**Re: 2021 Wildfire Mitigation Plan – Progress Report  
(Docket #2021-WMPs)**

**PROGRESS REPORT**

**RESPONSE TO ENERGY SAFETY REMEDIES**

**PG&E-21-01 THROUGH PG&E-21-28**

**FIGURE PG&E-4.5-3 PG&E: RISK MODELING CAPABILITIES IN THE MATURITY SURVEY (FUTURE STATE ~2023)**

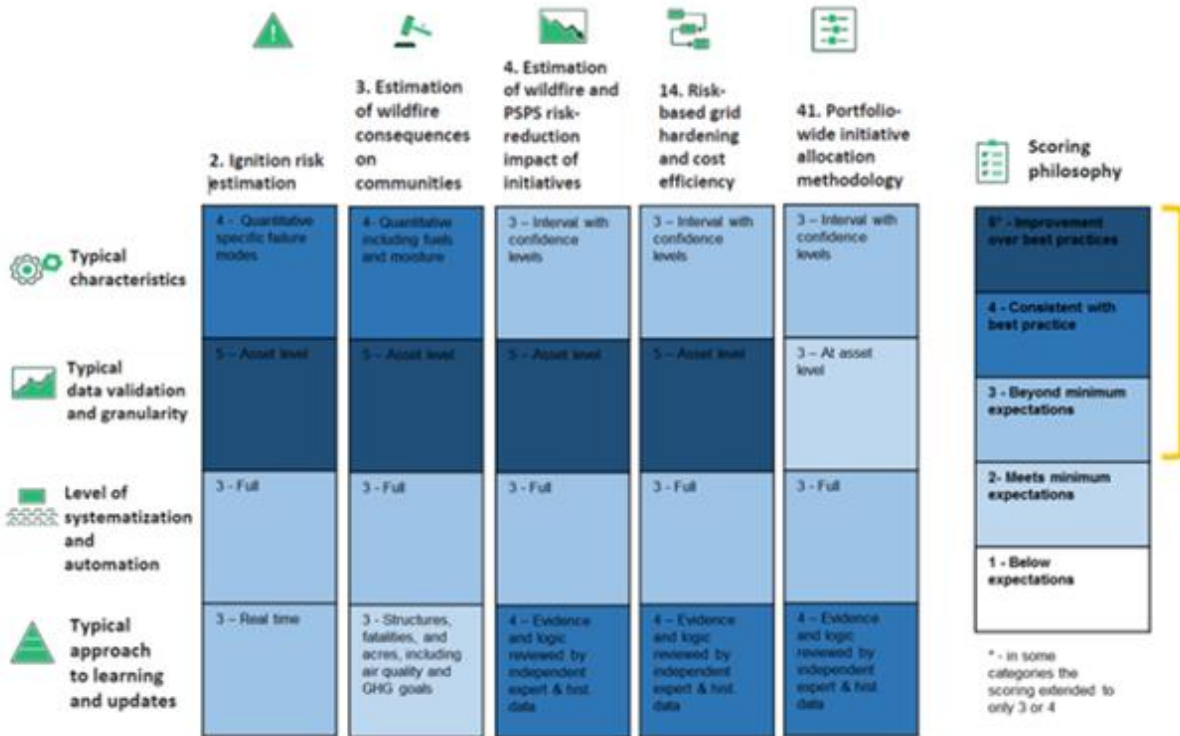
- 1) *Demonstrate that it is applying automation as quickly as possible, explaining any constraints on progress; and*
- 2) *Supply its workplan to enhance its modeling efforts.*

These improvements, as well as the development of modeling capabilities, are described in detail in our 2021 Revised WMP<sup>5</sup> and summarized in Figure PG&E-4.5-3 of the 2021 Revised WMP. A copy of Figure PG&E-4.5-3 is provided below for ease of reference. The schedule for model development over the next three years is shown below for the Wildfire Distribution Risk Model (WDRM) and Wildfire Transmission Risk Model in Figure PG&E-Remedy-21-03-1 below.

**FIGURE PG&E-REMEDY-21-14-01:  
MITIGATION DECISION TREE FOR SYSTEM HARDENING**

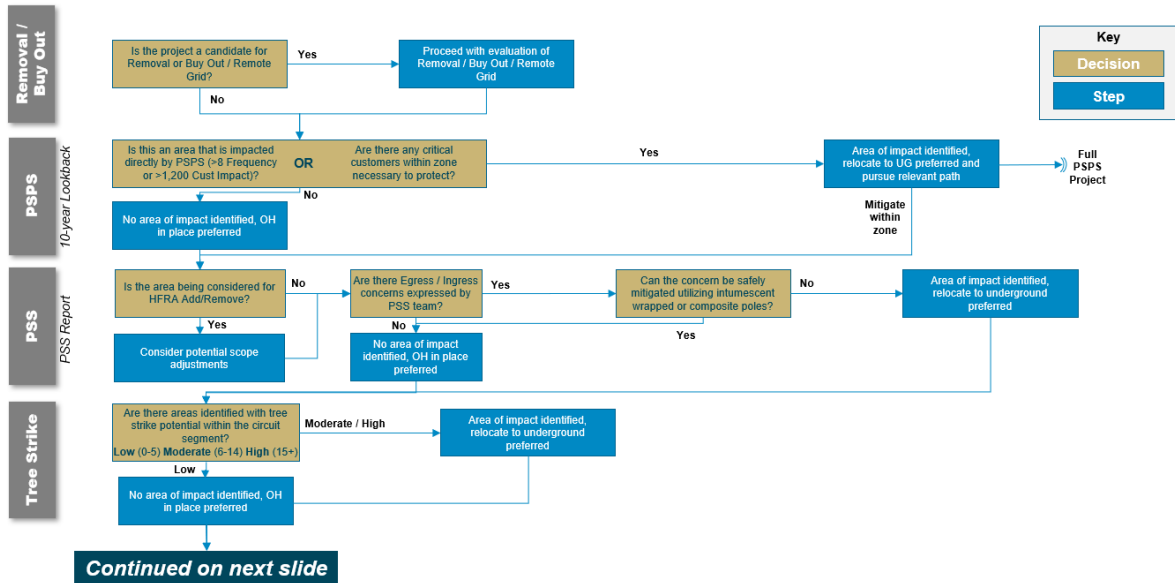
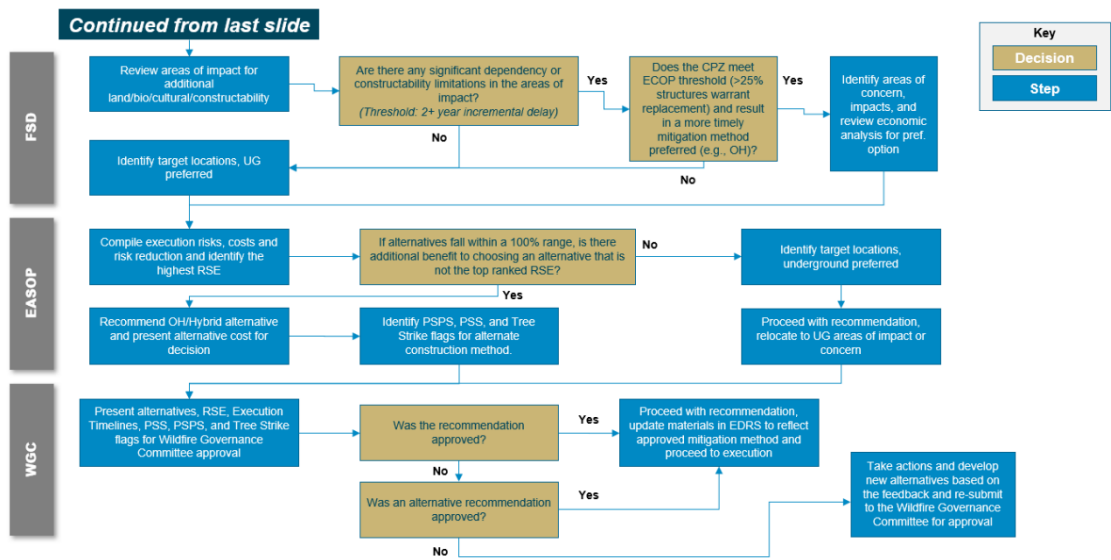
- 3) *Explain how, if at all, PG&E's recently announced undergrounding plan:*
  - a) *Changes its decision-making framework for initiative selection for individual circuit segments;<sup>32</sup> and*

- 3) PG&E’s decision to underground 10,000 miles of its electric system will not have an immediate impact on the decision-making framework for system hardening because we are currently in the initial stages of program development. However, we expect that our decision-making framework will evolve over time as we finalize the details of the undergrounding program. For System Hardening Program projects through 2023, we have used the existing decision-making framework, which is depicted in Figure PG&E-Remedy-21-14-01 below.

However, the framework will evolve over time based on: (1) improvements in our risk modeling; and (2) development of a more detailed plan for our 10,000 miles of undergrounding initiative. The decision-making framework will also be updated to reflect other WMP initiatives and operational changes, such
